ASSESSMENT REPORT

Commercial and Retail Development – Mount Street, North Sydney MP 08_0241 MOD 6

This report is an assessment of a request to modify the Concept Approval MP08_0241 for a commercial and retail development at 86-96 and 100 Mount Street, North Sydney.

Figure 3: Level 35 floor plan - approved (above) and proposed (below). (Source: approved and proposed plans)

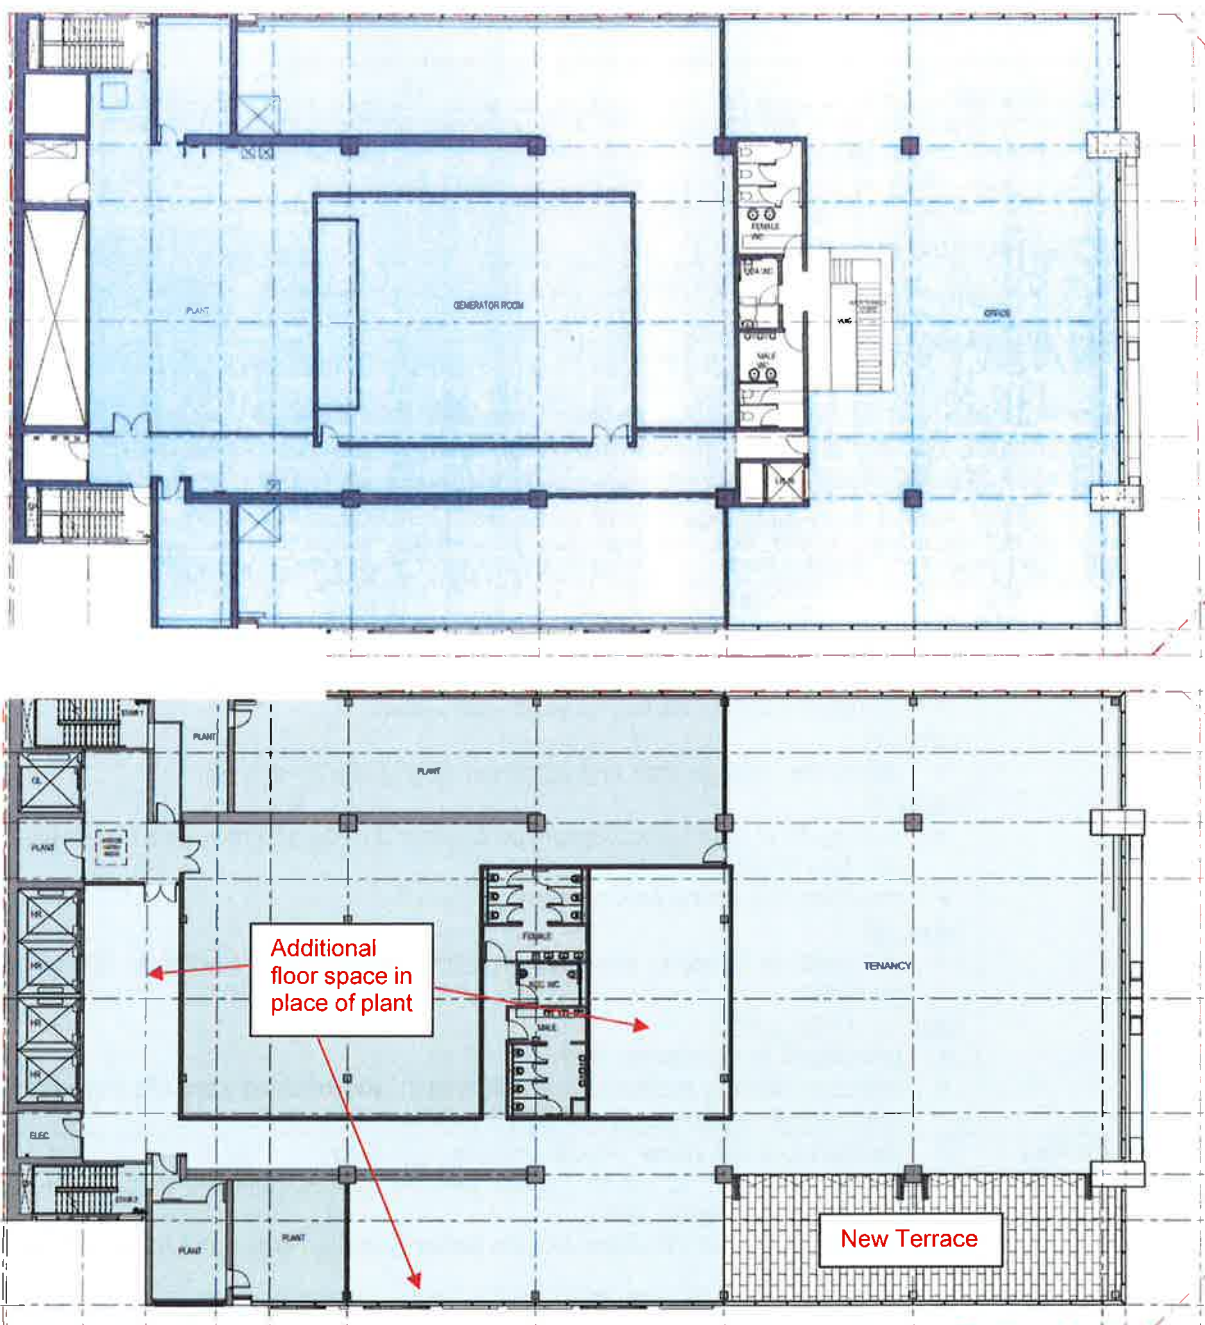
Changes to Floor Layout	<u>Ground Level</u> • Increase width of north and south entry stairs; <u>Level 34</u> • delete the internal stair and lift connecting levels 34 and 35; <u>Level 35</u> • change floor plan to incorporate an outdoor terrace and provide a new multi-function space; • changes to building service areas; <u>Level 36</u> • changes to building services including mechanical, electrical, fire and hydraulic; <u>Level 37 (Roof Level)</u> • provide lift motor rooms; and • relocate building maintenance unit (BMU) and building services including mechanical, electrical, fire and hydraulic services.
Bicycle Parking	• Redistribute the visitor bicycle parking, including: – retention of 12 visitor bicycle parking spaces adjacent to the Mount Street entrance; and – relocation of 26 visitor bicycle parking spaces within the basement on Level B2.
Building Facade	The proposed modifications include minor change to the façade at the top level of the building to accommodate the building services and lift overrun at Level 37.

<i>Increase in Gross Floor Area</i>	- The proposed modification would result in an increase of GFA from 47,186 m² to 47,450 m² (additional 264 m² or 0.5%). - The increase in GFA is a result of the provision of a multi-function space and its associated facilities on the new Level 35 in place of plant. - No objection was raised by Council regarding the proposed increase in GFA. - Concerns were raised in the public submission that the proposed increase in GFA would exacerbate the bulk and scale of the building. - The Department has considered the proposed increase in GFA and is satisfied the proposal is acceptable on the basis that:	The Department has recommended modified conditions relating to monetary contributions (conditions B5 and B6).

Figure 4: Roof level sections - approved (above) and proposed (below). (Source: approved and proposed plans).

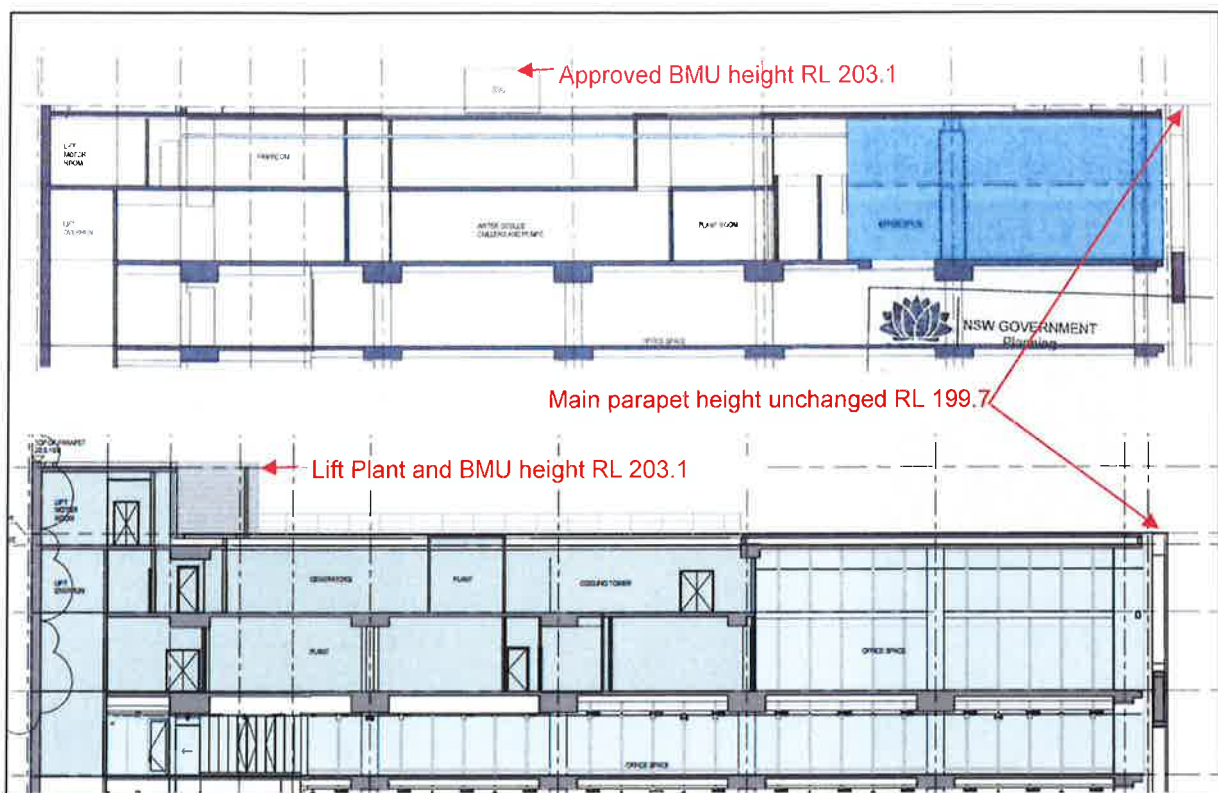
Design Parameter	Proposed Modification
Gross Floor Area	• Increase of GFA from 47,186 m² to 47,450 m² (additional 264 m²). • The increase in GFA arises from the changes at Level 35 to create the new multi-function space and its associated facilities.
Building Height	• The main parapet height of RL 199.7 remains unchanged. • The approved height of the roof level plant (RL 203.1) also remains unchanged, but the plant level is enlarged to incorporate stairs and lift motor rooms and is relocated from the centre of the building to its western edge.

Issue	Consideration	Recommendation
<i>Additional roof level plant and services</i>	- The proposed modification seeks to increase the extent of roof level plant and services, with the enlarged plant and service area re-located to the western edge of the building. - Concern is raised in the public submission that the proposal would exacerbate the non-compliance with Council's height controls, set an undesirable precedent for other building sites and result in amenity impacts in terms of loss of solar access, views, increased overlooking and sense of enclosure. - Council have raised no concern with the proposed roof level changes. - The Department notes a maximum height control of RL 195 applies to the site under North Sydney Local Environmental Plan 2013 (NSLEP 2013), however roof level plant to a height of RL 203.1 has already been approved on the site. The proposal does not seek to increase the maximum building height in this regard. - The Department acknowledges the enlarged and relocated service area would be more readily visible than the existing approved roof level plant. However, the Department is satisfied that the proposal would not result in any unacceptable impacts, noting that: - the revisions relate only to a small section at the western edge of the building and incorporate the approved façade materials and finishes so that as viewed from the street level and from other vantage points, the change to the overall appearance of the building would be minor and not readily discernible; - as viewed from the Beau Monde Building, the proposed changes to the western edge of the site are likely to be obstructed from view by an approved new development at 1 Denison Street, located between the two sites; - as a separation of 130 metres exists between the site, and the Beau Monde Building, the proposed minor changes would not result in any unacceptable amenity impacts in terms of loss of solar access, views, increased overlooking or sense of enclosure; - shadow diagrams indicate that the proposed changes would not result in any additional overshadowing of residential dwellings or material impacts to public domain areas; - a wind report submitted with the modification demonstrates that proposed minor changes would have a negligible impact on the pedestrian level wind conditions; and - the building form would continue to be compatible with the dense commercial built form context of the North Sydney CBD. - The Department is therefore satisfied the proposed minor changes to the roof level plant are acceptable in this case.	No additional conditions or amendments necessary.
